What to Audit and Rectify: UHCC PC42 - Mangaroa and Pinehaven Flood Extents

To: Hearing Commissioner (Hearing: 27th to 29th September 2017)

From: Save Our Hills (Upper Hutt) Incorporated (SOH)

■ **Figure 19 Current Existing vs. Future Case Comparison of Predicted Flooding Extents in the Q₁₀₀ with Climate Change.**

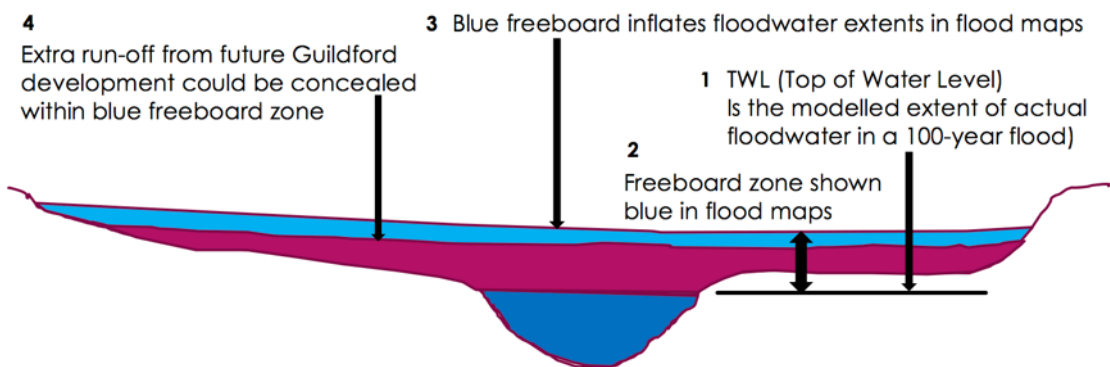
- viii. SOH has consistently challenged the misrepresentation of "the current situation" in GWRC's 100-year flood maps;
- ix. In particular, SOH has challenged SKM's reported assertion that the impact on flooding from future development on the Guildford land will be only 'minor' (GWRC's Pinehaven Stream Flood Hazard Assessment_May 2010 Revision E_Vol 1, Fig.19, p30 – see below);

- xx. SOH considers that the shading of freeboard as floodwater is probably the reason for the error in the reported result of SKM’s future case scenario (see ix above);

- xxi. SKM's future case scenario assumed 1,665 future dwellings on just part of the Guildford land, and reported that the effect of this high level of development on flooding would be 'minor';

- xxii. SKM displayed this erroneous conclusion in a map overlay which showed very little additional peak flow from future development beyond the extent of SKM's 1-in-100 year base flood map which claims to represent 'the current situation' (SKM's Pinehaven Stream Flood Hazard Assessment_May 2010 Rev E_Vol 1, Fig.19, p30 – see SOH slide 5.3);

- xxiii. SOH thinks the error [the "major issue" with regard to future development identified in the 2015 Audit – see (x) above] is that SKM's base map is inflated by the-freeboard-presented-as-floodwater device;

SOH Slide 5.7 (See SOH presentation #5 - Pinehaven Stream Flood Mapping Audit 2015)

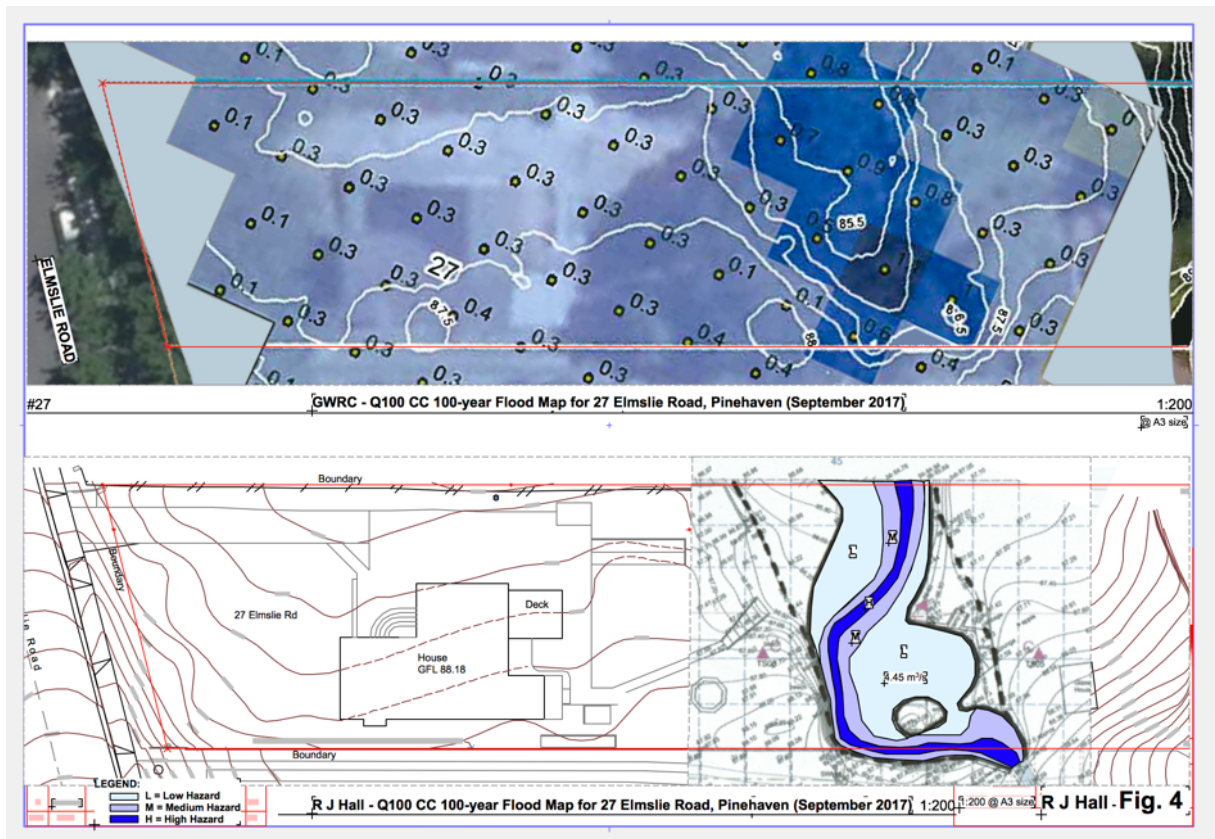
Unsatisfactorily, the 2015 audit suggests... extra run-off from future development can go in the blue freeboard zone without materially affecting the flood maps

"the effects of future development on flood extent are not modelled correctly. However... because there is freeboard incorporated into the results, the flood maps are unlikely to be materially affected by this apparent anomaly."

Is this why HVFMS (GWRC, HCC and UHCC) and their experts and consultants have insisted all along that freeboard must be modelled as floodwater, to accommodate future run-off from the Guildford development?

- xii. This circular argument (that there isn't any material problem with the flood maps because additional peak flow from future development on the Guildford land can combine with freeboard-presented-as-floodwater to resolve any apparent anomalies) assumes [incorrectly] that it is acceptable to fill freeboard with additional peak flow from future development, flow that did not exist in the "current situation" before the arrival of new development on the Guildford land!

- xiii. This is strongly challenged by SOH (see SOH slide 5.7 above) because the additional peak flow (extra run-off from future Guildford land

development) makes the true current situation WORSE (the top of actual water level) but doing so stealthily within the blue-coloured freeboard extents;

SOH Slide 3.23 (See SOH presentation #3 – Flood Maps Must be Accurate – 27 Elmslie Road)

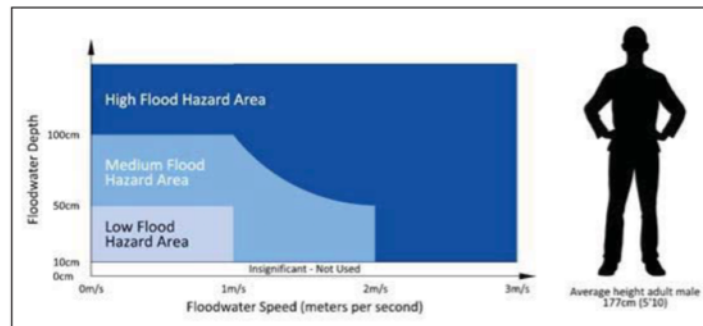
- xxx. Meanwhile, GWRC and UHCC misuse of freeboard as floodwater creates a misleading impression of actual flood water extent, and is

the main reason for the difference between GWRC’s inflated 100-year flood hazard map for 27 Elmslie Road and R J Hall’s correct 100-year flood hazard map of actual flood water for the same property (see SOH slide 3.23);

xxx. R J Hall concludes “My assessment of the situation on the Pattinson’s property [27 Elmslie Road] and the deficiencies evident in both the UHCC and GWRC flood hazard maps are likely to be present elsewhere in the catchment and not limited simply to the Pattinson property and accordingly this indicates to me that a critical review of what is presently being made available with respect to the nature and the extent of the flood hazards in the Pinehaven and Mangaroo catchments needs to be undertaken to ensure that what is eventually produced serves the purpose of presenting flood hazard information in an informative and accurate way that can readily be understood by the community.” R J Hall evidence, para. 33(d)

xxxii. SOH requests that the independent critical review recommended by R J Hall be carried out, and expects that it is HIGHLY LIKELY that the review WILL result in significant changes to the flood modelling and mapped hazard extents, as exemplified in xxx (SOH Slide 3.23) above.

SOH Slide 5.9 (See SOH presentation #5 - Pinehaven Stream Flood Mapping Audit 2015)

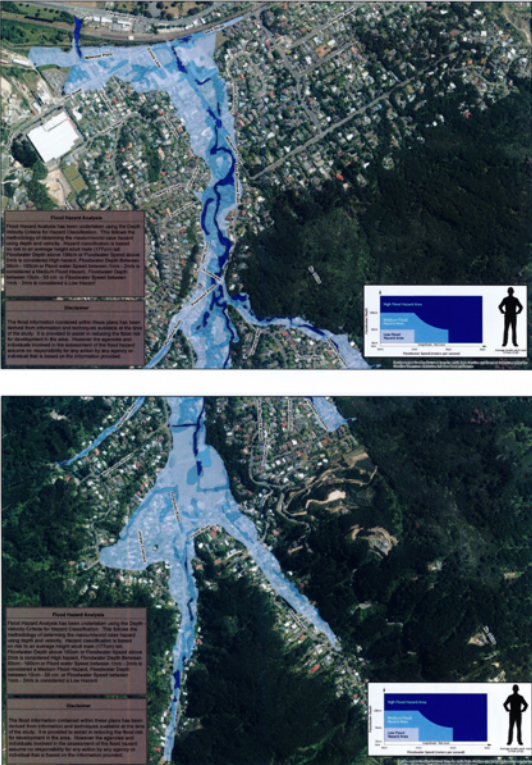
- e. What SOH wants is simple: “*...true flood hazard maps, based on the combination of water depth and flow velocity at any location ... to understand potential danger to people, and ... readily calculated from the outputs of 2D hydraulic models ... not show[ing] any hazard in the buffer [freeboard] zone*” (See SOH slide 5.9);

- g. Note that the diagram in SOH Slide 5.9 (which is from the 2015 Audit, p23) indicates that flood water depth less than 10cm is of insignificant risk and therefore not mapped;

For example, describing the area covered by freeboard beyond the modelled flood extent as a Flood Sensitive Area may be more transparent and more appropriate than GWRC’s use of all-encompassing Flood Hazard Areas. Changing the name would allow GWRC to provide true flood hazard maps, based on the combination of water depth and flow velocity at any location. These flood hazard maps can be particularly informative in areas where flood extents are large, but there is also deep or fast flowing water in defined flow paths or depressions. Figure 6.4 shows how flood hazard is defined in Hamilton, while Figure 6.5 shows an example of a flood hazard map from the UK based on similar principles.
